CREST ROAD C&D MATERIAL RECOVERY FACILITY
420 CREST ROAD
HENDERSON COUNTY, NC

OPERATIONS PLAN

NOVEMBER 2011
REVISED FEBRUARY 2012

The responses to the comments that you provided on 12/15/2011 are bulleted below each corresponding comment in ***bold italic*** text.

CREST ROAD C&D MATERIAL RECOVERY FACILITY
SITE OPERATIONS LAYOUT

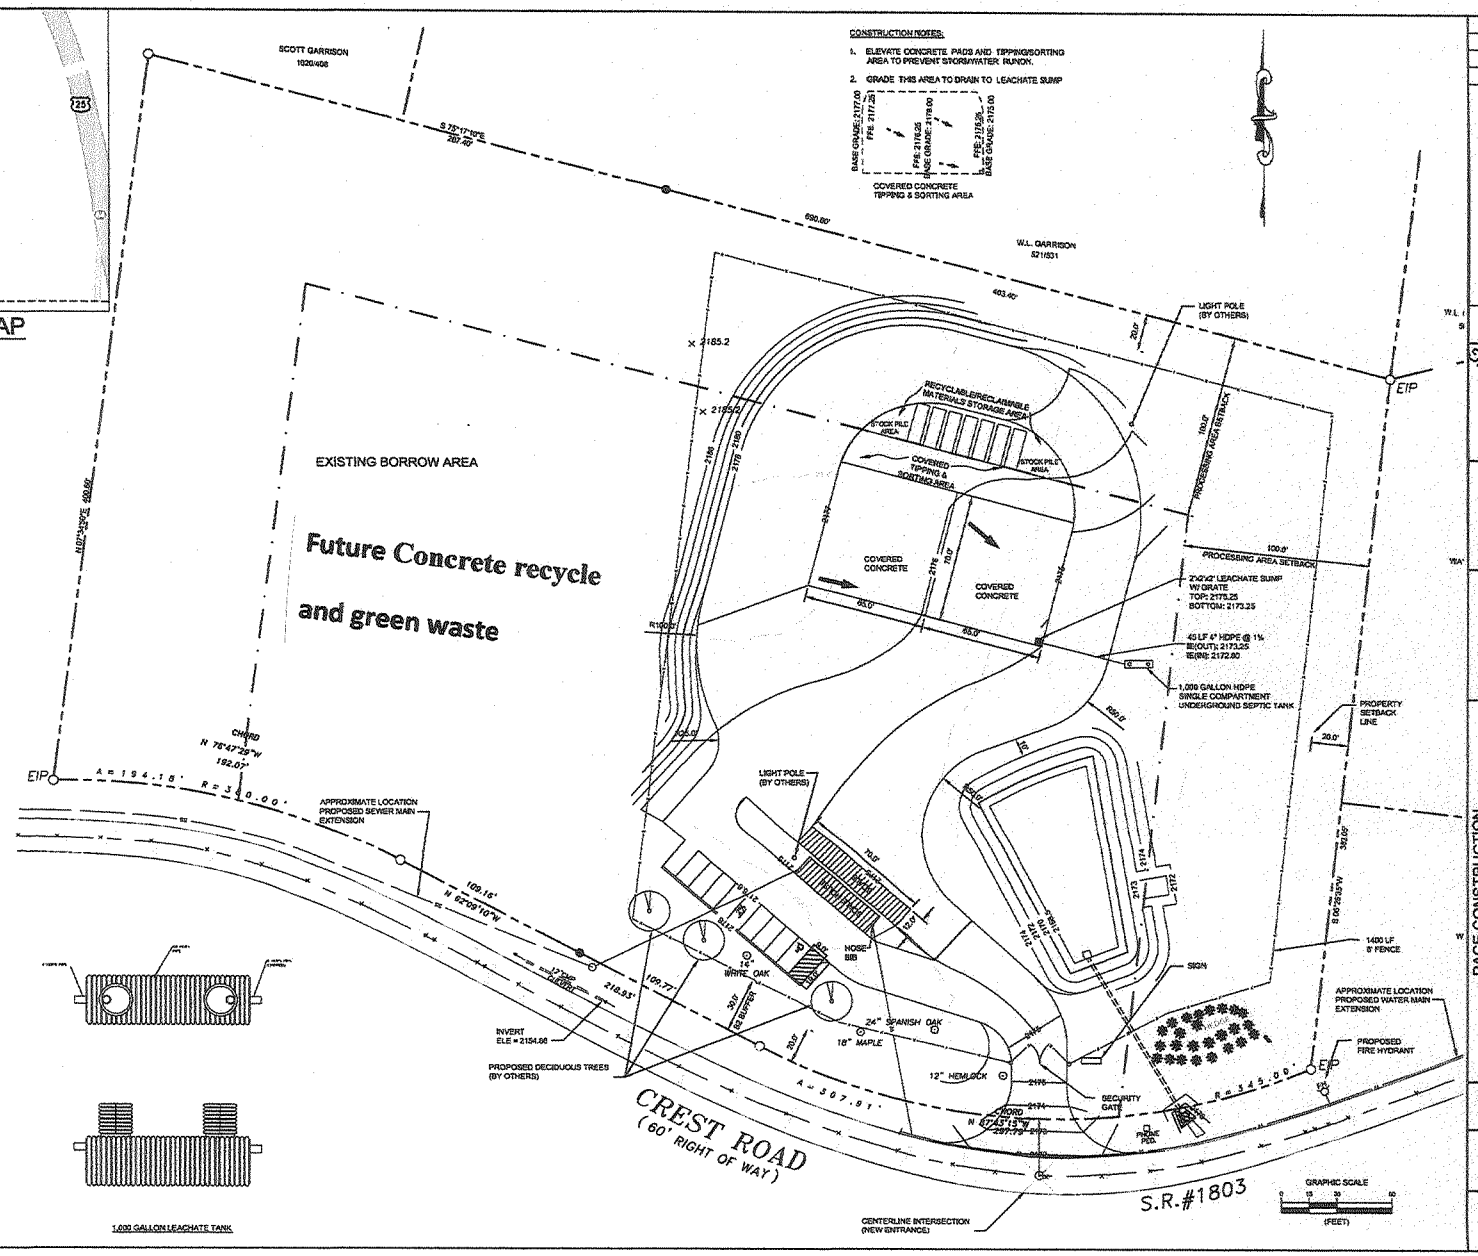
1. gates/fences or other access control features (access roads must be of all weather construction),
    - ***8' fence already proposed on drawing, Access gate added***

2. utilities (wastewater system and stormwater drains),
    - ***Proposed water and sewer main extensions are shown in R.O.W.***
3. any recyclable storage areas indicating types and sizes of containers,
    - ***Containers added to drawing***
4. leachate and runoff collection details,
    - ***Site Operations Plan revised and E&S Plan and details provided.***
5. buildings (existing and proposed), picking lines and scales/scale house, and
    - ***Shown on drawing***
6. concrete foundations/pads and all other ground cover for the site operation.
    - ***Shown on drawing***
